Rezoning Transportation Analysis

Petition Number: 2026-001

General Location Identifier: 05326108, 05326109

Date	Description
2-25-26	First Review (IW)
5-18-26	Second Review (IW)
6-22-26	Third Review (IW) ZC

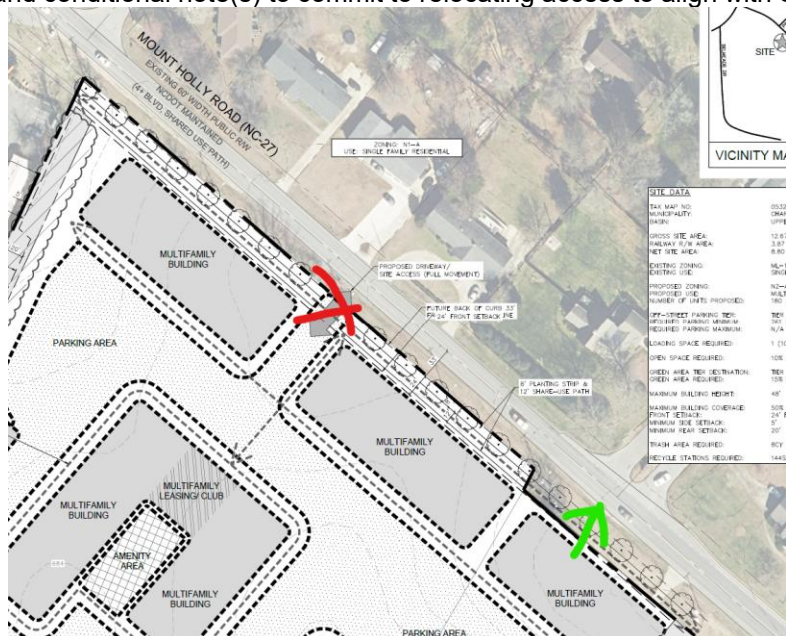
1. Curbline:

- a. ~~Mt. Holly Road: Location of future back of curb and gutter to be constructed 33 feet from centerline.~~

~~4+ Boulevard, Shared Use Path from Streets Map~~

Label and dimension the curb and gutter from the centerline for each road on the site plan.
